United States Patent and Trademark Office

APPLICATION NO.	I	FILING DATE	FIRST NAMED INVENTOR	ATTORNEY DOCKET NO.	CONFIRMATION NO.	
10/680,166	10/680,166 10/08/2003		Yasushi Yamagoshi	040894-5958	5804	
9629	7590	03/13/2006		EXAMINER		
= = :		& BOCKIUS LLP	WATKO, JULIE ANNE			
WASHING		IIA AVENUE NW C 20004		ART UNIT	PAPER NUMBER	
,				2653	<u></u>	
				DATE MAILED: 03/13/2006	5

DETAILED ACTION

Morioka Fig. 2, annotated

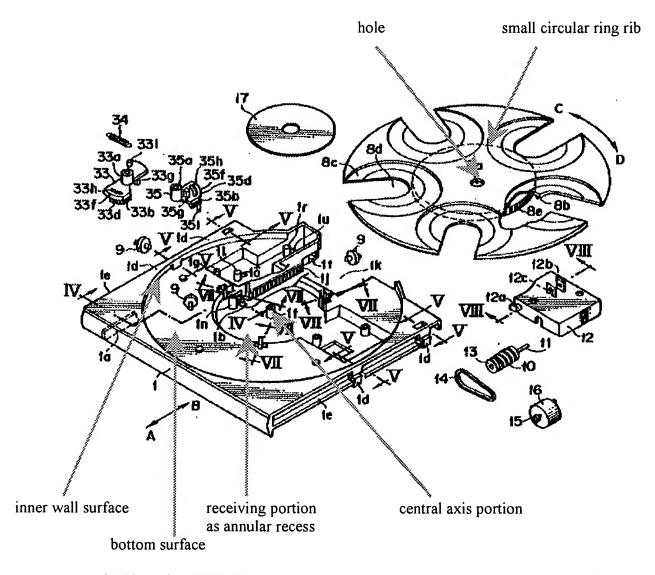
As recited in claim 2, to the extent understood, Morioka shows a disk table rotation structure, comprising: a tray 1 having an inner supporting wall surface (see Fig. 2, annotated below) that stands upward, inside of the inner wall surface, a central axis portion 1F that stands upward on a center portion of the bottom surface, and a receiving portion disposed around the central axis portion; a disk table 8 having a central through hole portion 8a opened in a center portion and into which the central axis portion is inserted, and a small circular-ring rib 8e extending downward from a periphery of the central through hole portion, the small circular-ring Application/Control Number: 10/680,166

rib positioned close to the bottom surface of the tray to support rotatably the disk table on the tray.

As recited in claim 3, Morioka shows that the receiving portion is an annular recess formed on the bottom surface of the tray (see Fig. 2, annotated above).
